CONNECTICUT RIVER FLOOD CONTROL

HARTFORD DIKE

WALL DETAILS - DUTCH POINT STATION

STEEL REINFORCEMENT NO. 4

PRECAST CONCRETE PILES
(FOR ALTERNATE SEE SPECIFICATIONS)SCALE: $\frac{1}{2}$ " = 1'-0"

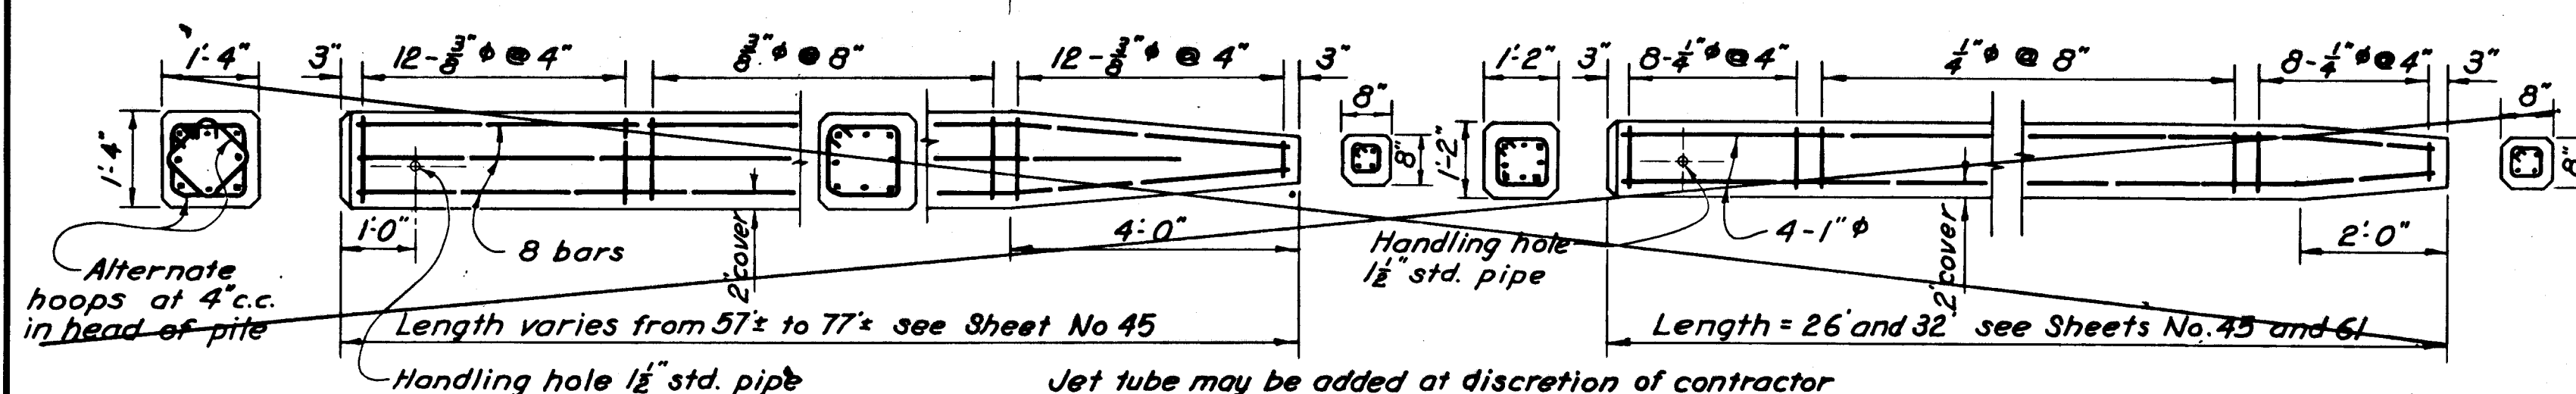
Steel H-section bearing piles substituted for concrete piles.
